Revised Fire Department Requirements 7.1.19

City of Stevenson | Stevenson Fire Department

Option A: Concept Rendering

Option A: Floor Plan © 2018 Mackenzie | 2180163.00

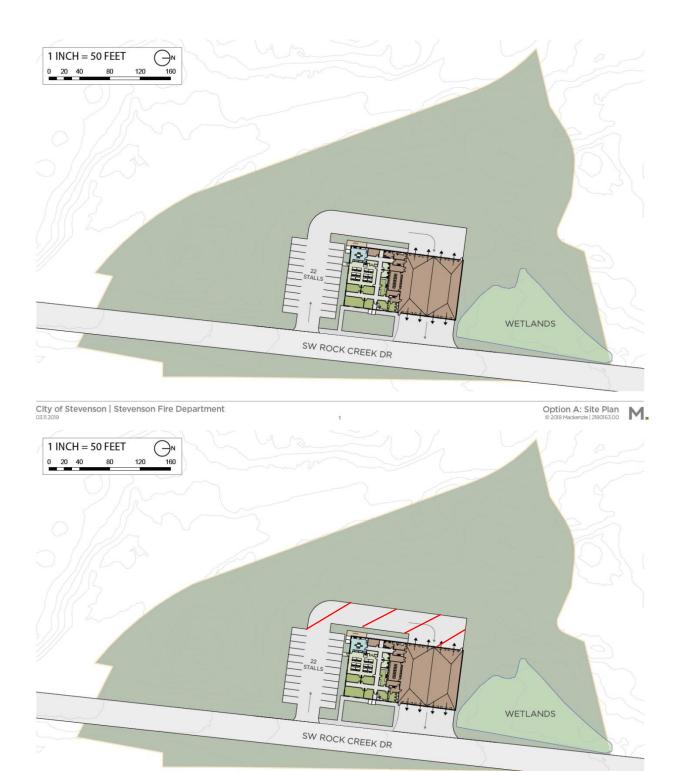
Proposed Reduction from Mackenzie Layout

Remove DEM (EOC)

Remove Kitchen

Remove second restroom in office area

Remove Chief's Office

Remove Some Storage inside of Office area

Remove Drive through App Bays

Remove double deep App Bays

Remove Second Decon Area leaving one room that is slightly bigger that on layout
